VECTOR® 1950 ST & MT – INTRODUCTION OF NEW ELECTRONIC CONTACTORS

ENHANCED RELIABILITY | SIMPLIFIED WIRING | DIRECT REPLACEMENT

POLARITY ON C30 CONTACTOR

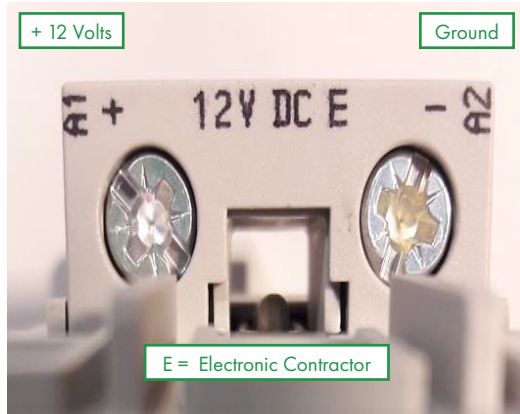
Unlike older magnetic contactors, new electronic contactors are polarity-sensitive.

- Connect positive (+12V) and ground as marked on the new contactor.
- Incorrect wiring may cause system failure.

- C30 Contactor (Electronic Type) – Ensure Correct Positive & Ground Connection

POLARITY ON C30 CONTACTOR

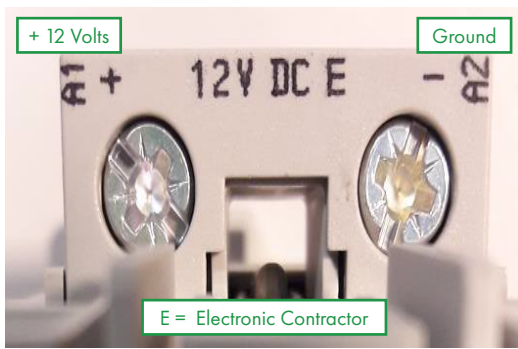
! Similar to Vector 1950, these new contactors are polarity-sensitive. Ensure correct positive/ground wiring.
